CITY OF ALBUQUERQUE

INTER-OFFICE MEMORANDUM

SUBJECT: **AC-24-21**, VA-2024-00233, PR 2022-006844

Danny Senn appeals the Site Plan-Administrative decision to approve a Site Plan for all or a portion of TRACT A THE PEARL ADDITION (being a replat of Tracts 107-B, 107-C together with Tract 106-A within projected Section 18 T10 N, R3E) zoned MX-M and R1-A, located at 1701/1623 Central Avenue, NW containing approximately 0.5767 acre(s). (J-13)

Figure 3. The Pearl, mixed-use development, approved Site Plan.

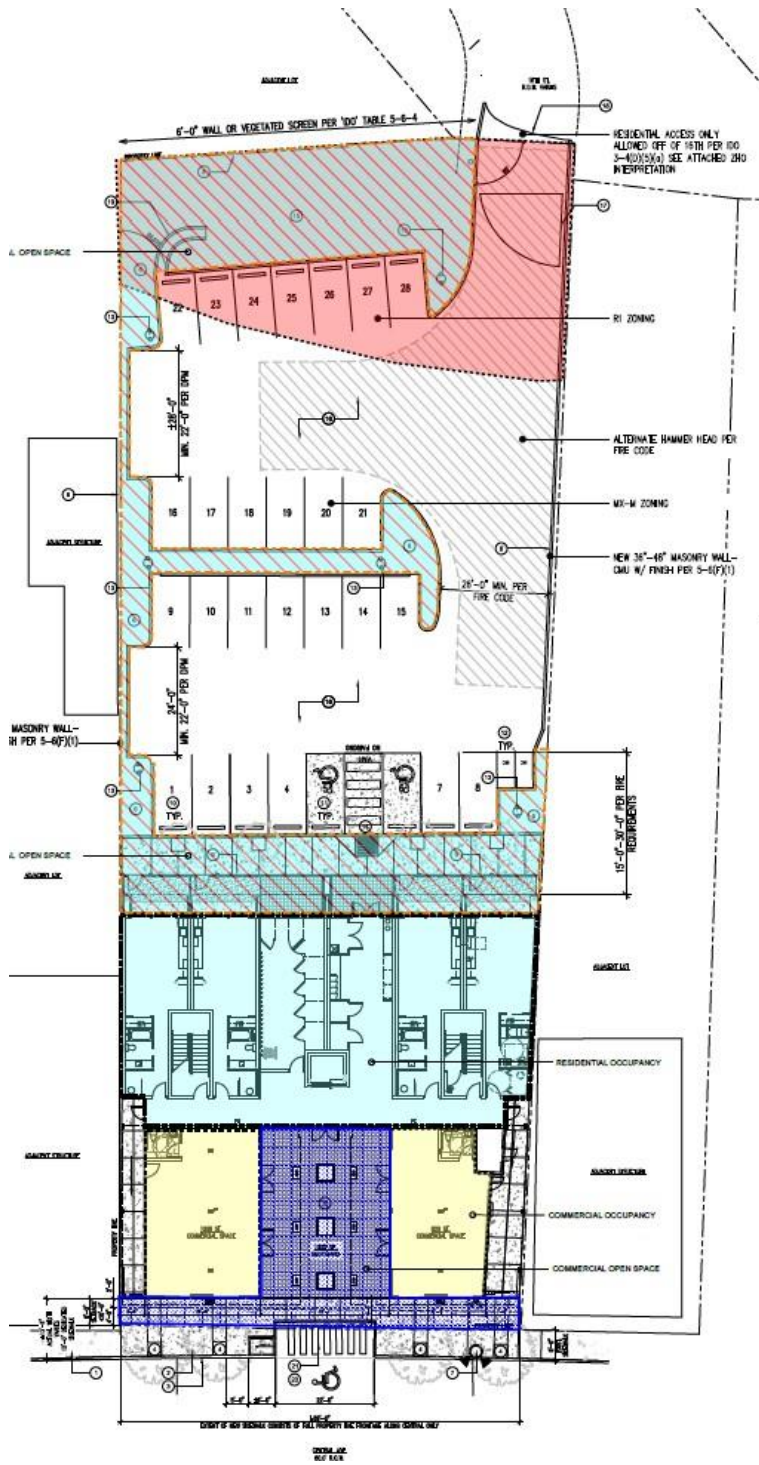
1. **Appellant:** IDO 6-4(V)(4)(a). The well-being of the 16th Street Neighborhood has not been addressed and are arbitrarily ignored by proposing traffic access on a very narrow street.

2. **Appellant:** Referring to IDO 'Access and Connectivity Section' IDO 14-16-5-3(A)(4) and (A)(5). There is an impact on the 16th St neighborhood directly behind the property in which the traffic from this proposed building will be diverted. It is not an efficient or convenient access, and the issue of mitigating the traffic impact has not been addressed responsibly.

Staff Response: The appellant refers to the IDO review criterion for an appeal and appears to assert that the staff acted arbitrarily in reaching its decision. The appellant associates a claim of the wellbeing of the neighborhood with traffic access to 16th Street.

Staff incorporated a 2022 ZEO Interpretation in its review of the multi-family access. The ZEO interpretation focused on the question: Does the IDO provision 14-16-3-4(D)(5)(a)2. Parking Access prohibit parking access to *residential* development along Central Avenue from 15th Street, 16th Street, and Fruit Avenue. The ZEO determined that the provision does allow access for residential uses to 16th Street.

16th Street measures approximately 27 feet from face-of-curb to face-of-curb. 16th Street is classified as an Access Local. Its current width of 27 feet is within the current design standard of 26-28 feet face-of-curb to face-of-curb for an Access Local. The Traffic Engineer allowed the residential portion of the project to access 16th Street because it is the function of an 'Access Local' to provide access to parcels, as opposed to 'Limited Access' streets, and the street is wide enough to perform this function.

Staff used DPM standards regarding the Traffic Impact Study (TIS) and for the Traffic Circulation Layout (TCL). The traffic generated from the proposed development falls well below the 100 trips during either the AM or PM peak hour threshold where Transportation can require a TIS (DPM 7-5(C)). There are only 22 total trips generated by the development in the AM Peak Hour and 34 trips generated in the PM Peak Hour, substantially below the 100-trip threshold.

The **commercial** portion of the project would generate approximately 5 trips in the AM peak and 7 trips in the PM peak, based on the latest ITE Trip Generation Manual. The commercial trips only affect traffic on Central. The cars are parking offsite, except for a dedicated ADA space, which was secured through an agreement with the Department of Municipal Development which oversees Central Avenue operations. The customers will have primary access to the commercial building via vehicle, transit, or walking and only from Central Ave. The commercial users will have with no vehicle access from 16th Street.

The **residential** portion of the project will generate approximately 17 trips in the AM peak hour and 27 trips in the PM peak hour, based on the latest ITE Trip Generation Manual. All required residential parking is located north of the multi-family building with access via 16th Street, which is permitted by IDO Subsection 14-16-3-4(D)(5)(a)2.
